**HINO MOTORS USA FKA COMMERCE PARK JSP 17-02**

Public hearing at the request of D& G Investments for Preliminary Site Plan, land bank parking, non-minor wetland permit, woodland permit and Storm water Management Plan Approval. The subject property is located in section 16, southwest corner of Twelve Mile Road and Taft Road and is zoned OST (Office Service Technology). The subject parcel is approximately 15.56 acres. The applicant is proposing to build a 124,418 square foot building along with associated site improvements, including parking and utilities. The proposed site plan also proposes to land bank up to 77 parking spaces of the 398 required spaces.

**PLAN REVIEW CENTER REPORT**  
**Planning Review**  
 April 5, 2017  
**HINO MOTORS USA (fka Commerce Park)**  
 JSP 17-02

Figure 1. City of Novi Regulated Wetland & Woodland Map (approximate project boundary shown in red). Regulated Woodland areas are shown in green and regulated Wetland areas are shown in blue).

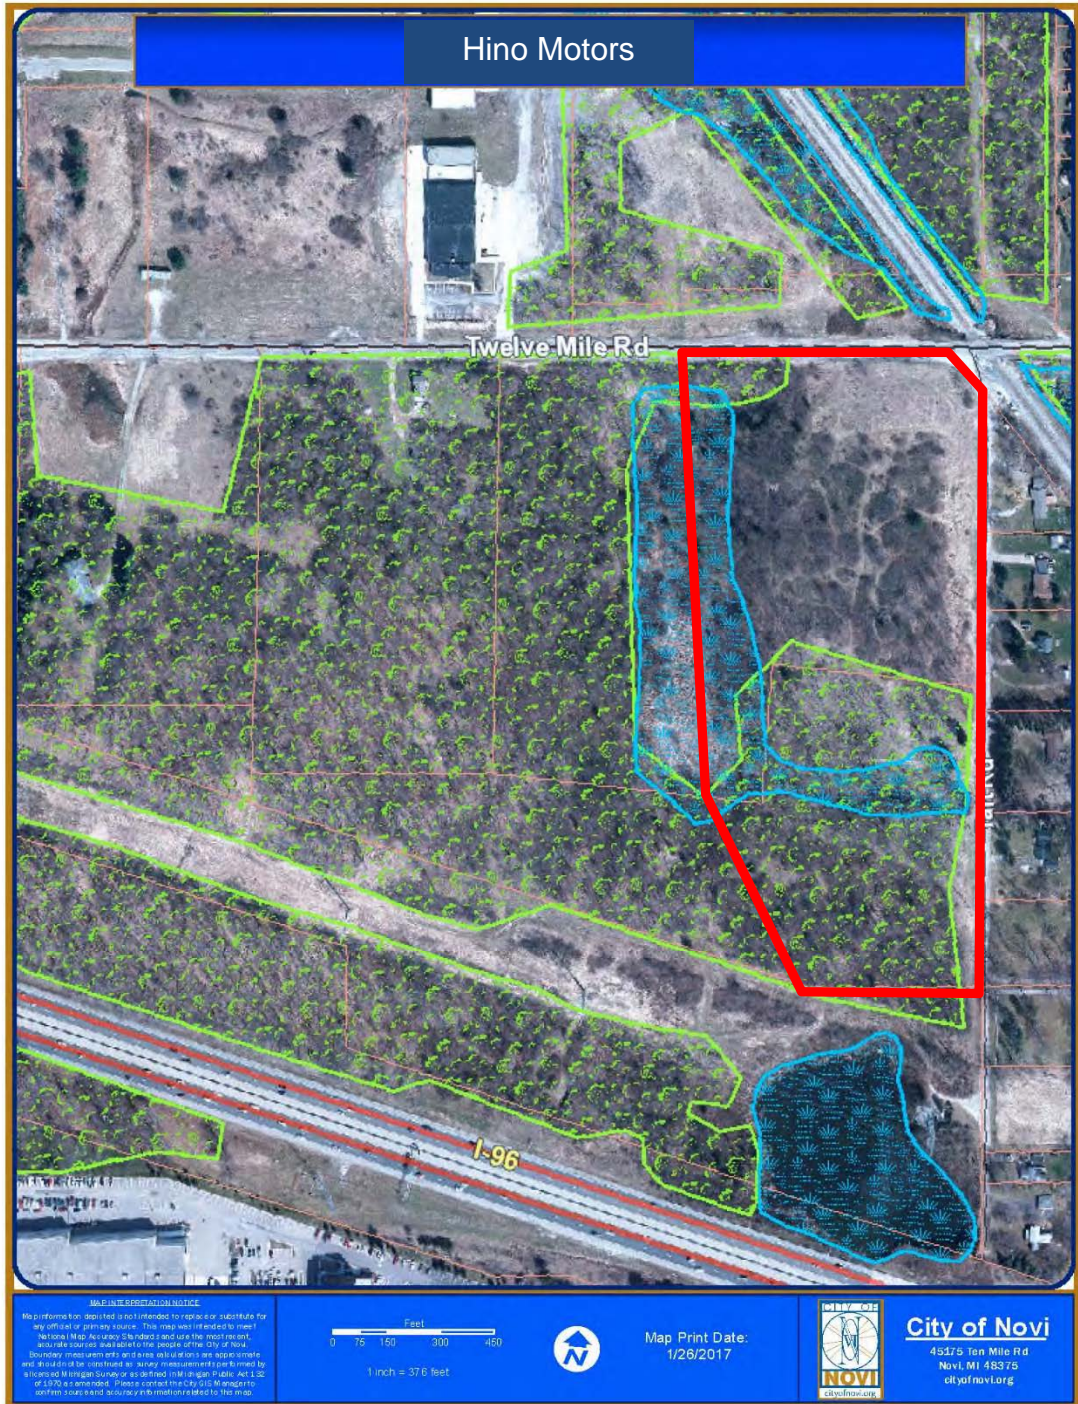
ECT's in-office review of available materials included the City of Novi Regulated Wetland and Watercourse map, USGS topographic quadrangle map, NRCS soils map, USFWS National Wetland Inventory map, and historical aerial photographs. Based on historic aerial photos (1940 and 1963, available from the Oakland County Property Gateway; <https://qgis.oakgov.com/PropertyGateway/Home.mvc>), the eastern half of parcel 50-22-16-226-004 had been agricultural land. The site includes areas indicated as City-regulated wetland on the official City of Novi Regulated Wetland and Watercourse Map (see Figure 1).

Figure 2. Preliminary Site Plan. Approximate wetland boundaries are shown in green.

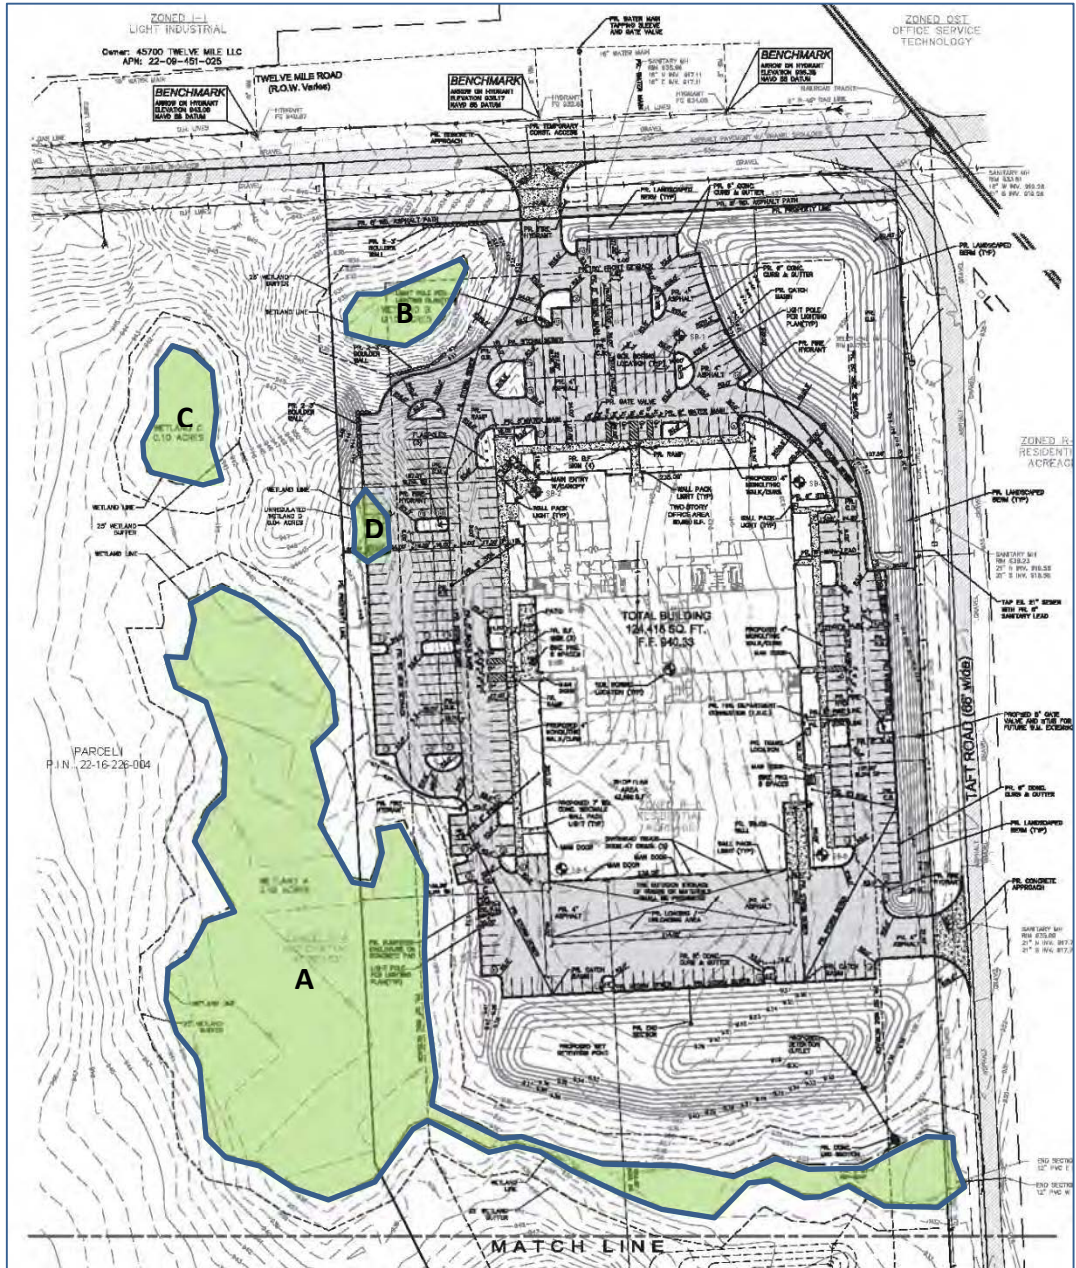
ECT visited the site on January 31, 2017 for the purpose of a wetland boundary verification with the applicant's wetland consultant Nowak & Fraus (NF). The focus of the inspection was to review site conditions in order to determine whether on-site wetlands are considered regulated under the City of Novi's Wetland and Watercourse Protection Ordinance. Wetland boundary flagging was in place at the time of this site inspection. ECT and NF identified four wetland areas (Wetlands A, B, C and D) in the field (see Figure 2 and Site Photos):

FIGURE 4

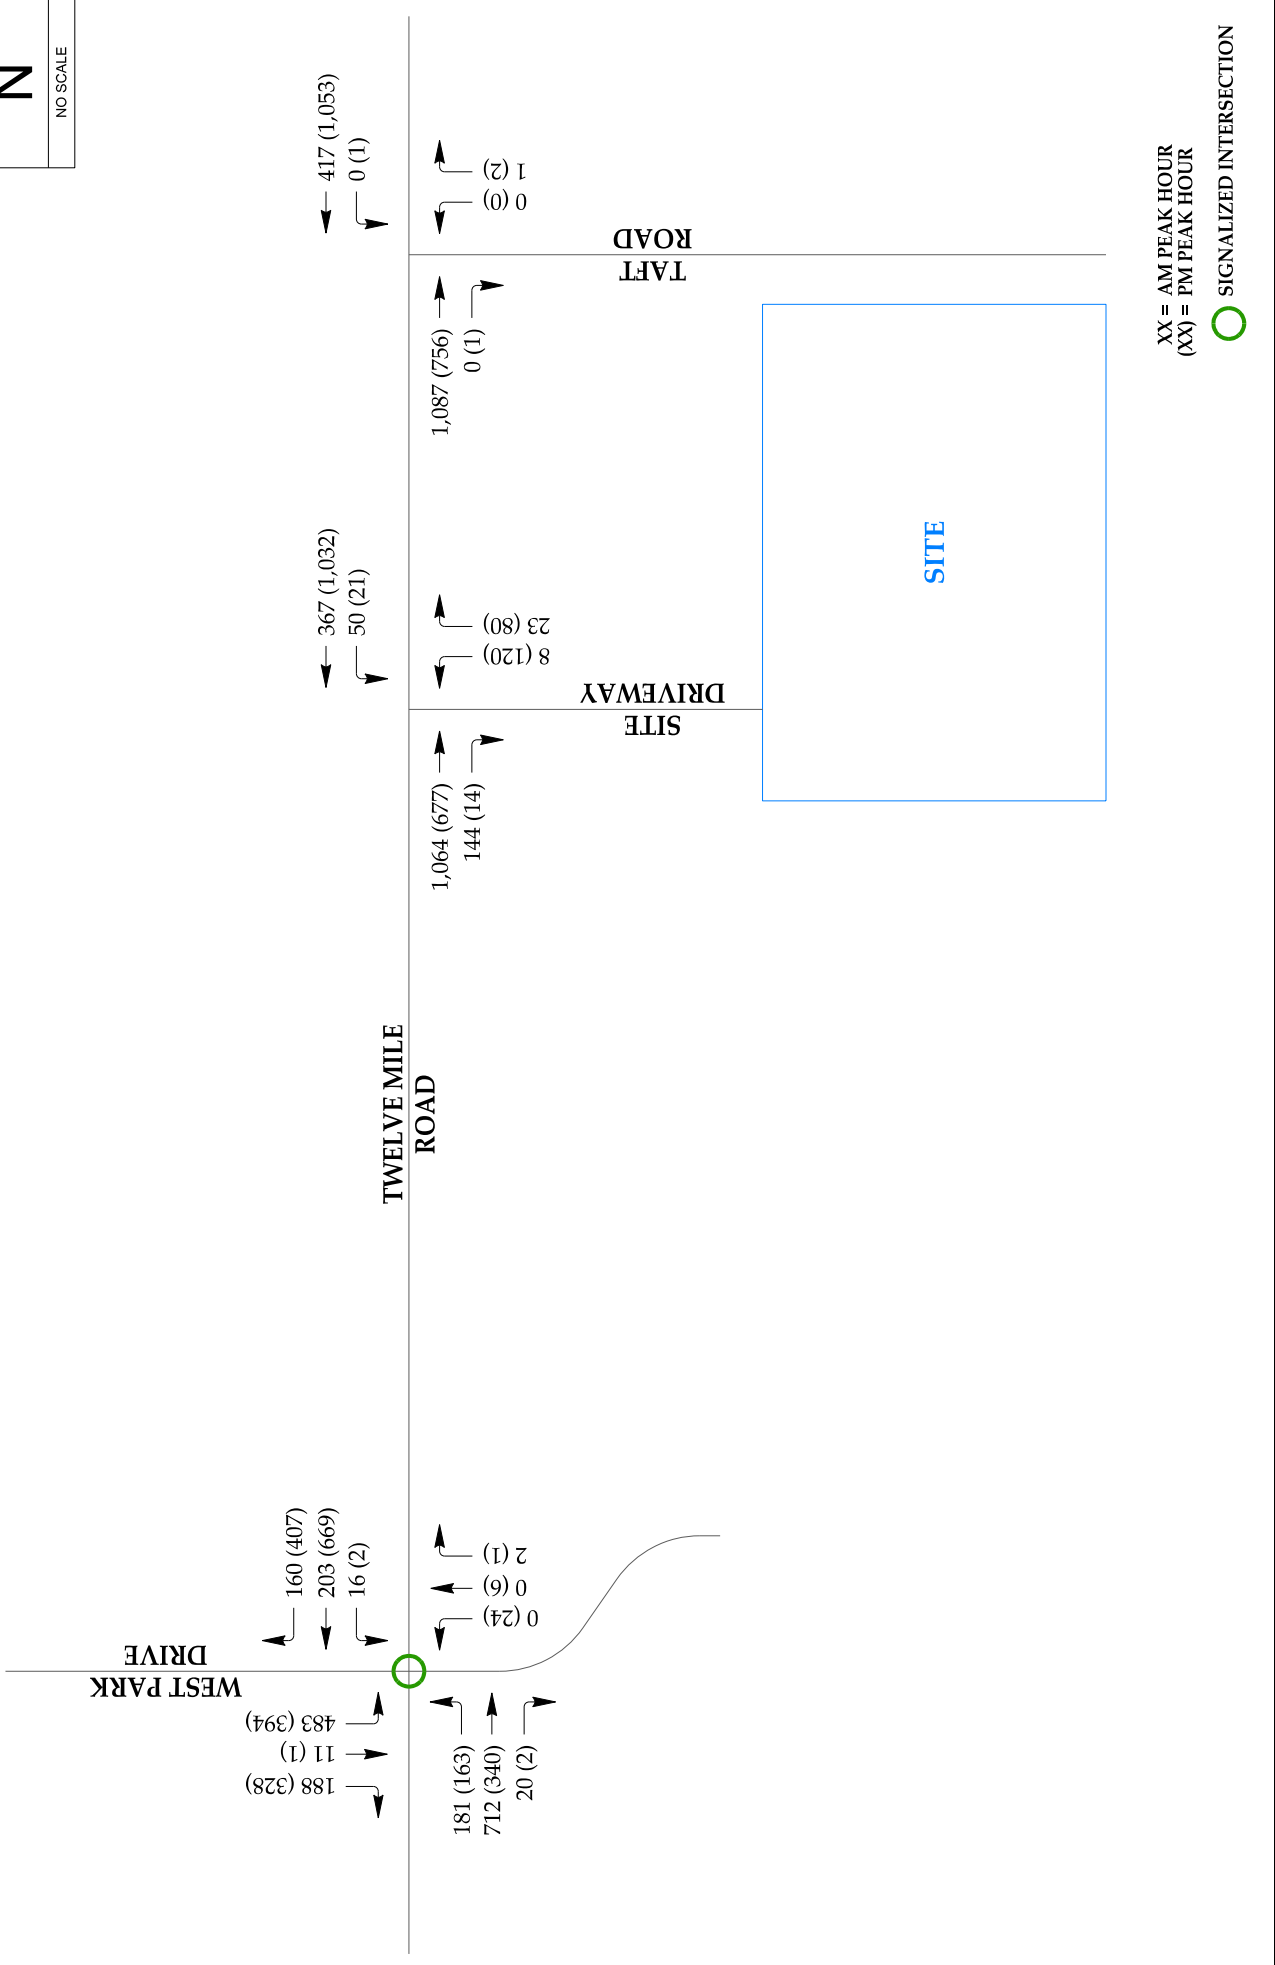
1. Trips were distributed for the site based on existing traffic volumes on Twelve Mile Road.
2. Within the report, the details of how the trips were distributed are inaccurate for the PM peak hour. The given percentages are reversed for east and west, and should be updated for consistency. The actual calculations within Figure 4 of the appendices are correct.
